ADDENDUM NO. 2

Date: January 26, 2018

Project: Phoebe Hearst Class Size Reduction Restroom

JOB NUMBER: _____ SHEET NUMBER: _____
 DATE: 25 JUNE, 2017
 DRAWN BY: SJT
ADD-2 CCD-1 A101

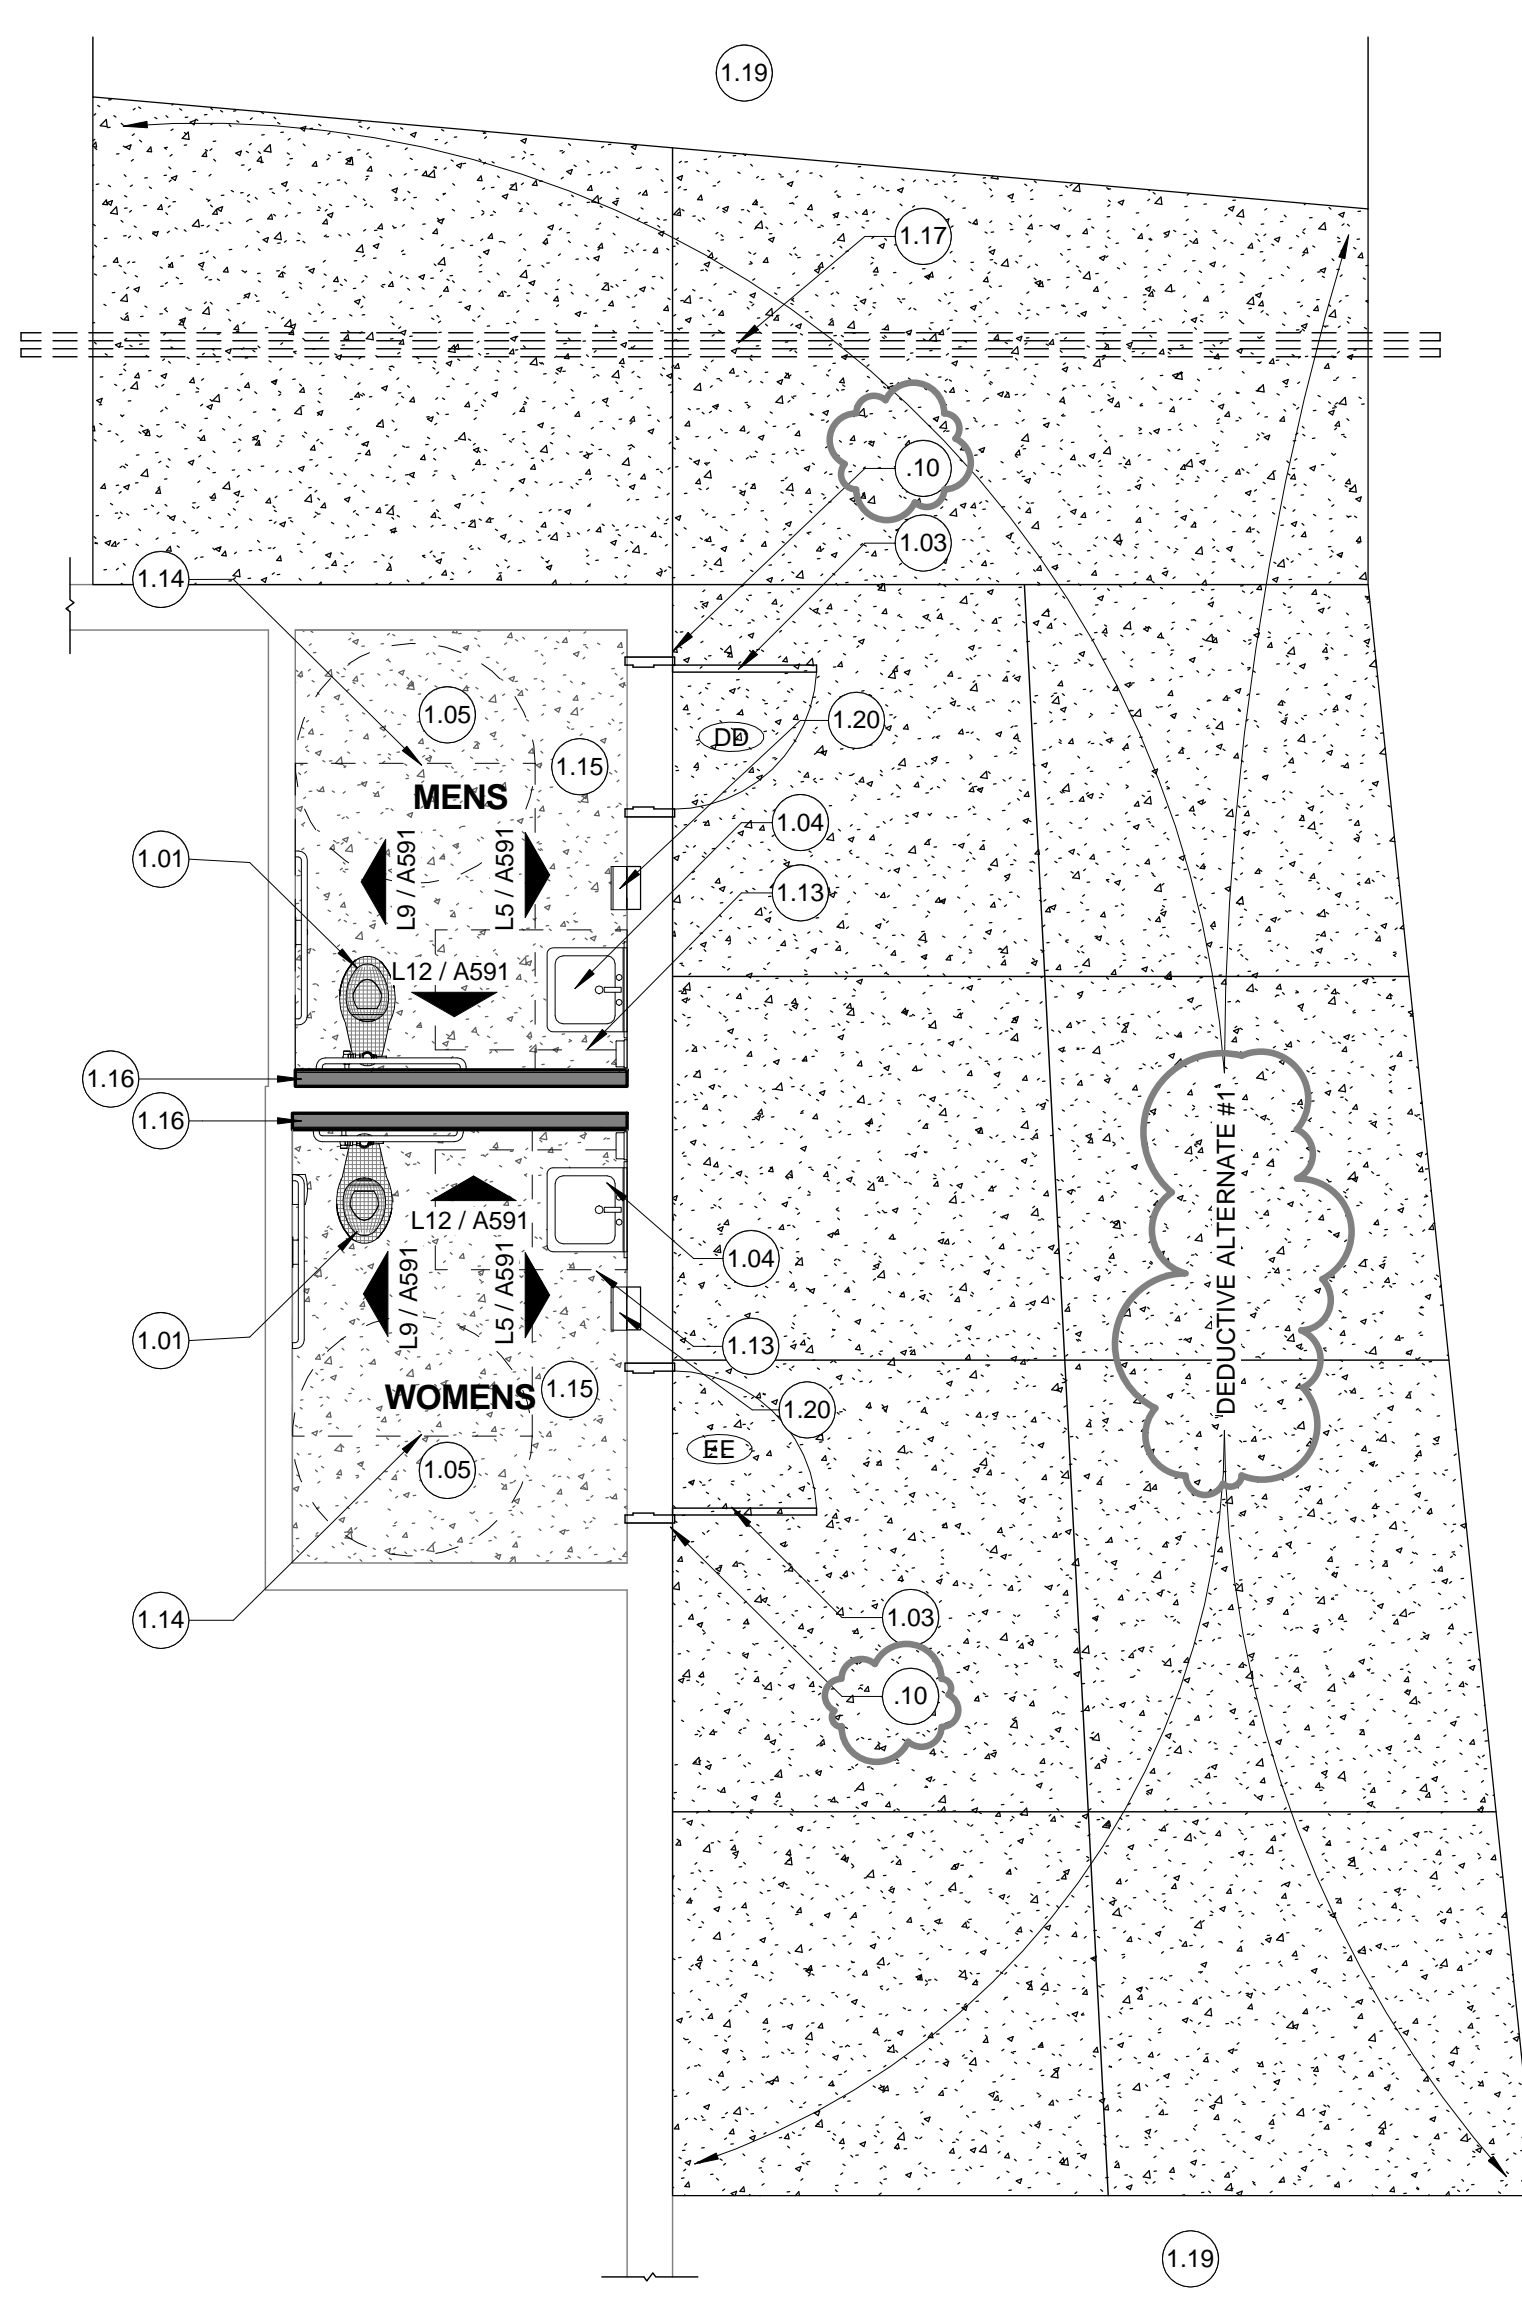
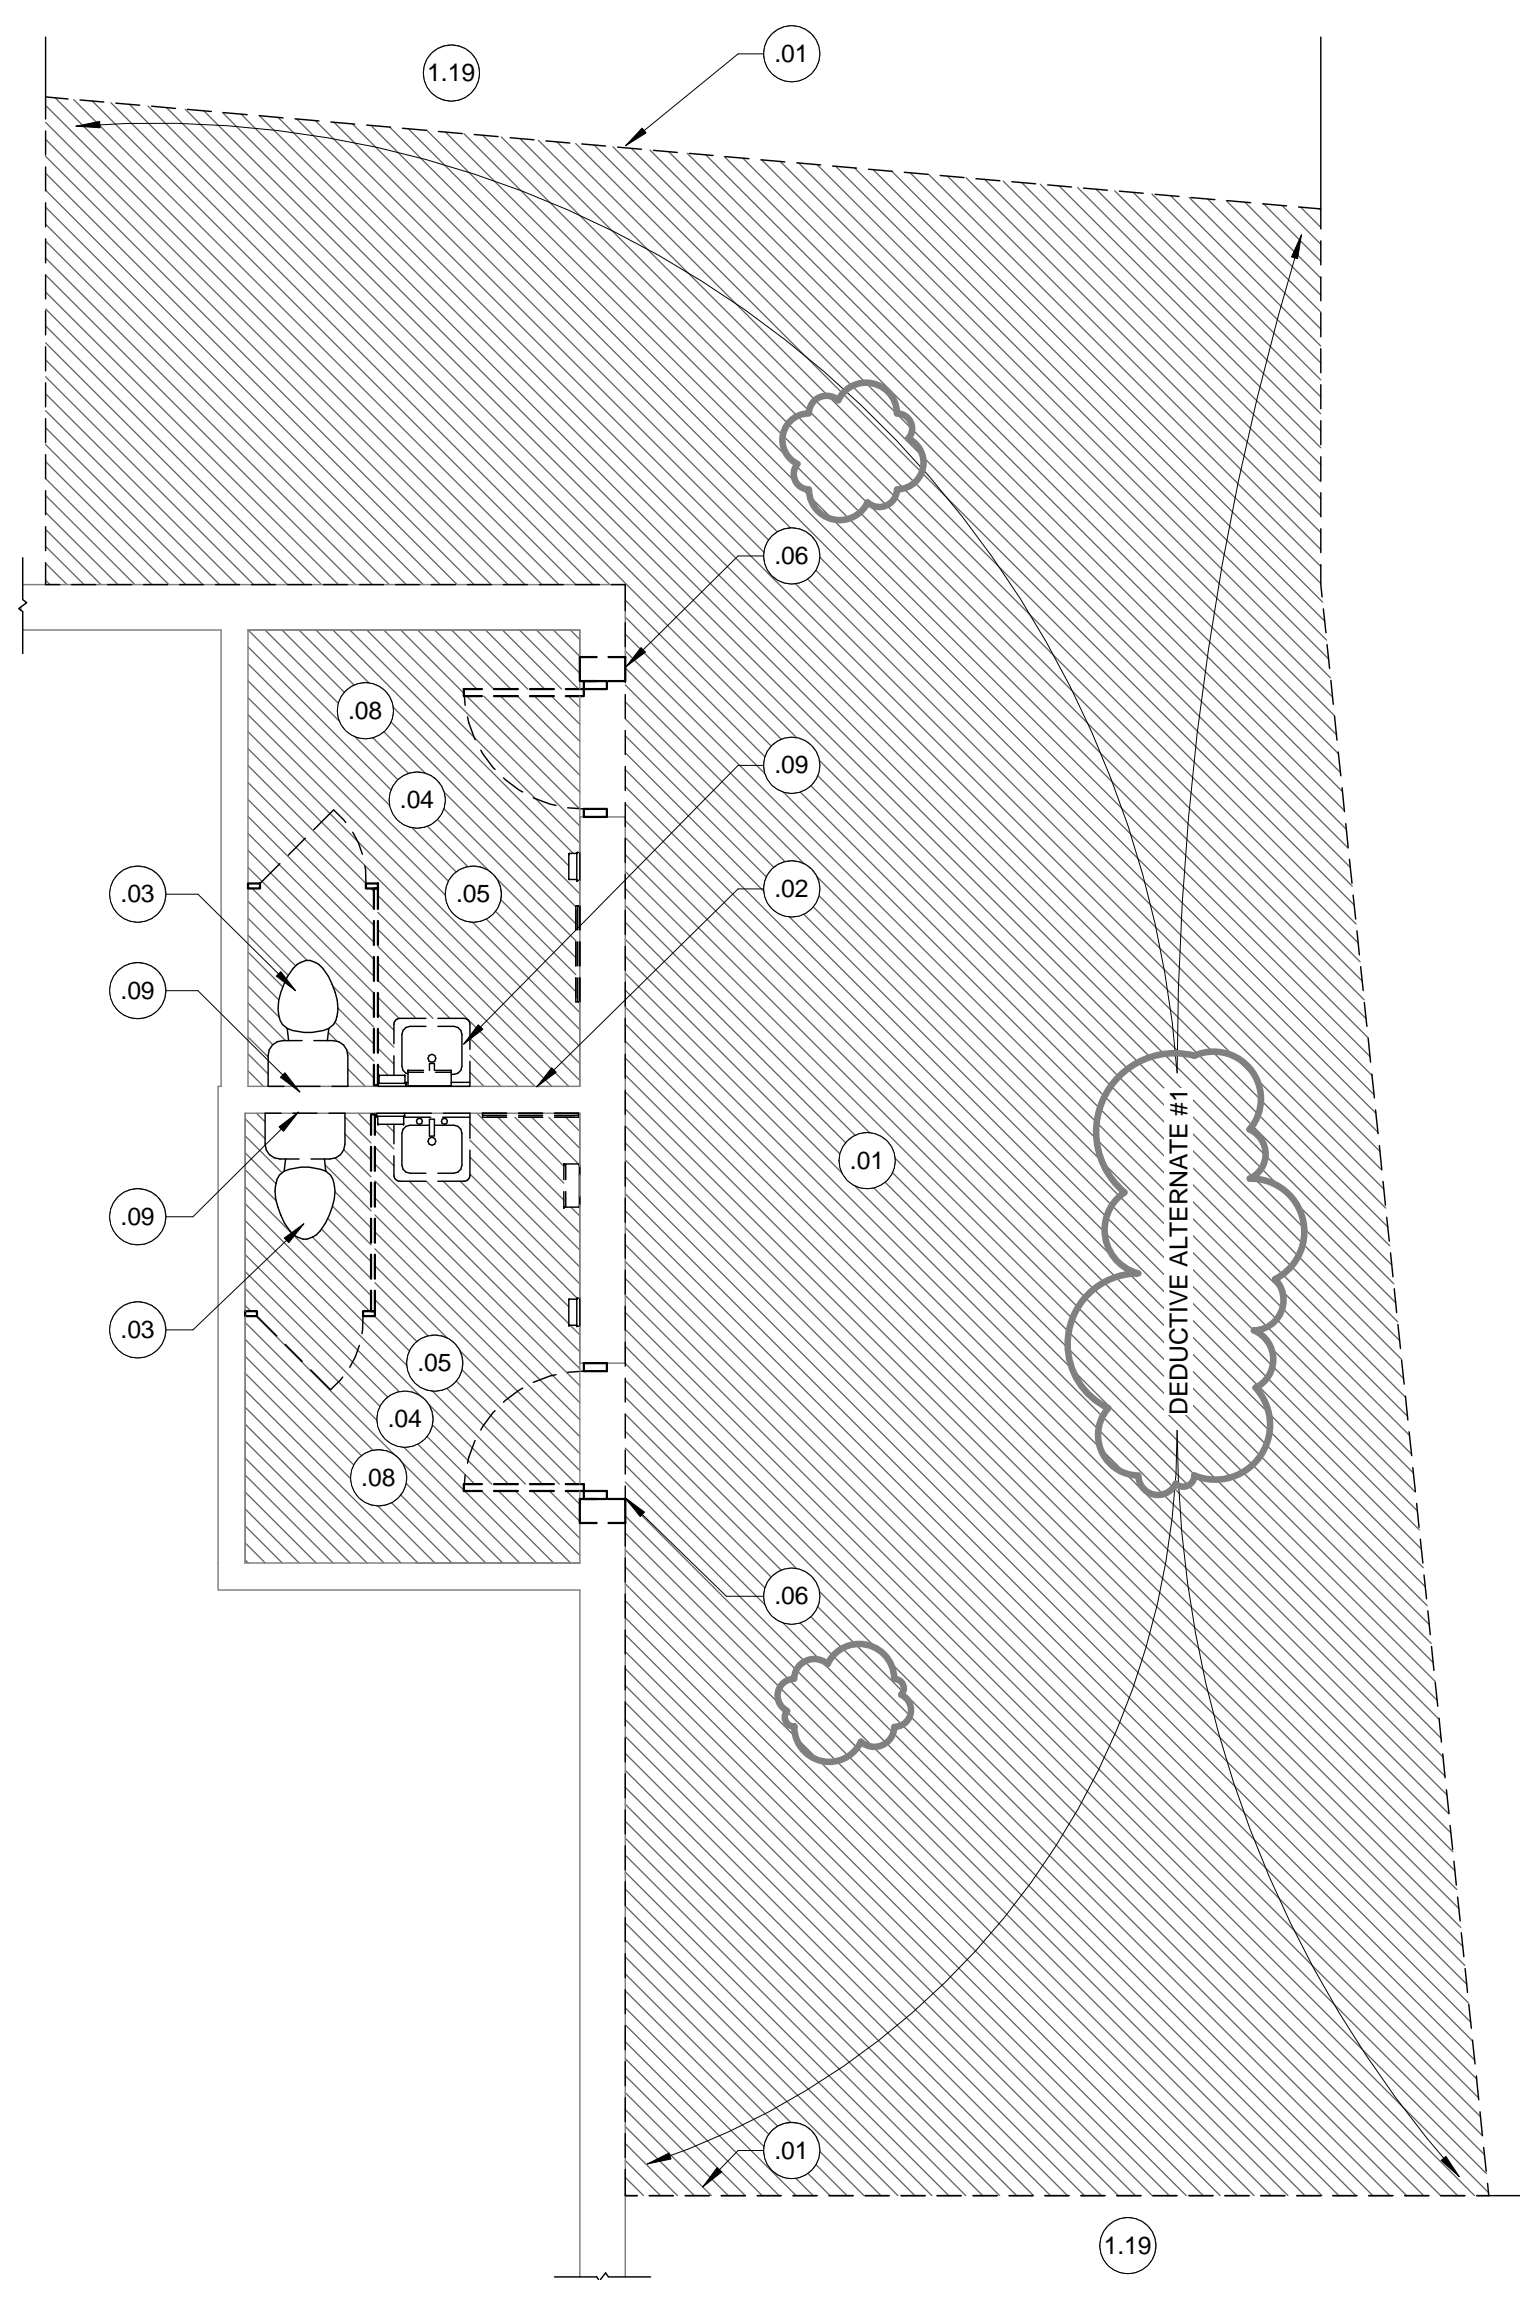
ITEM # 2.5 Sheet CCD-1 A101 – Partial Floor Plans: Replace this sheet with the attached Sheet ADD-2 CCD-1 A101 – Partial Floor Plans. All changes have been clouded.

- A. The Alternate descriptions below are general in nature and for reference purposes only. The Contract Documents, including, without limitation, the Drawings and Specifications, must be referred to for the complete scope of Work.
 - 1. Alternate # 1 – Deductive: Deduct pricing for demolition, disposal, removal, and replacement of exterior concrete slab on grade walkway, labeled as Alternate # 1 on Sheet ADD-2 CCD-1 A101. ze
